AQUA LUNG Military Tech Bulletin

**SUBJECT: UPDATE TO G2000SS & G3000SS SERVICE KITS
Bulletin No 18-002**

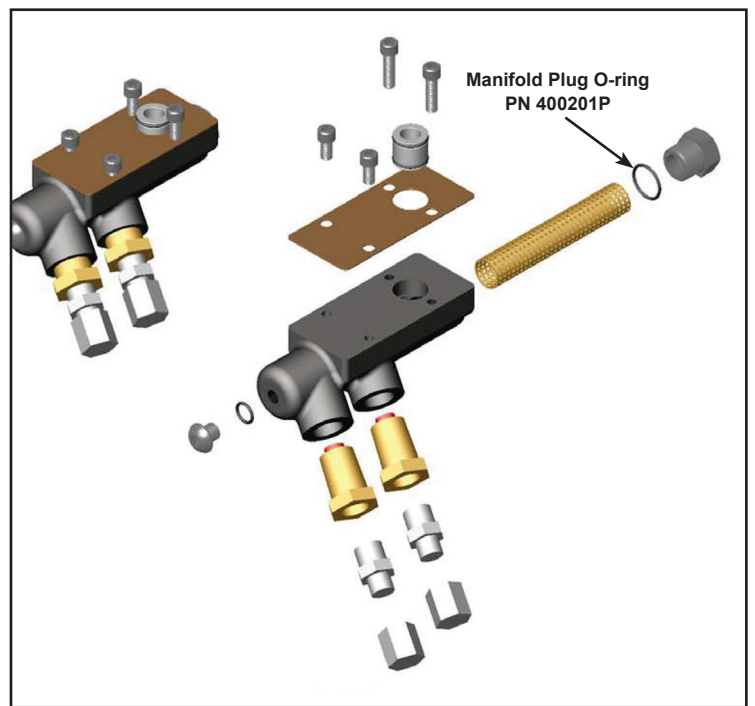
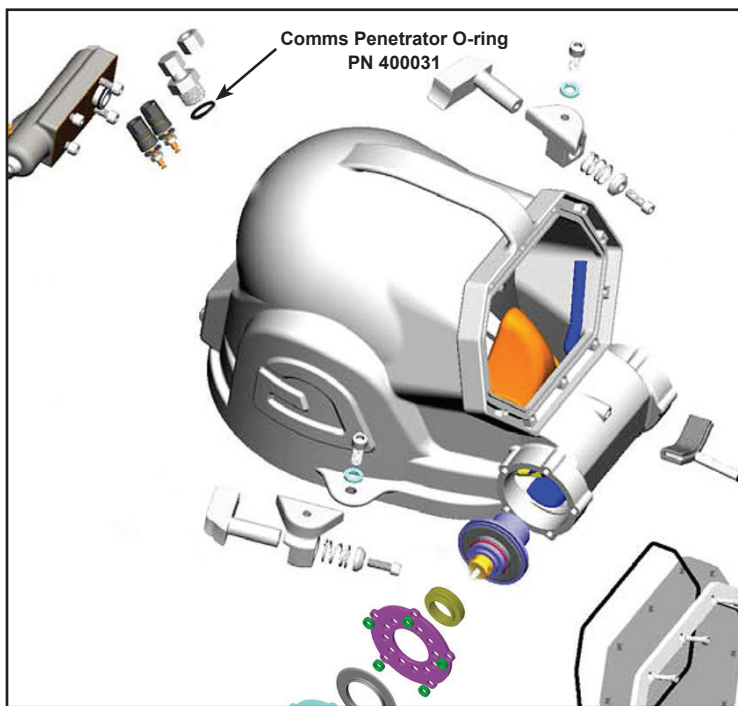
This bulletin serves to notify customers of a change to the G2000SS and G3000SS annual service kits. Each service kit previously contained two manifold plug o-rings PN 400031, one for the manifold plug PN 400030 and one for the bulkhead comms plug PN 400017. Updated service kits will now contain one manifold plug o-ring PN 400201P and one comms penetrator o-ring PN 400031.

All service kit cards and technical manuals have been updated to reflect the necessary mentioned changes as of May 30, 2018.
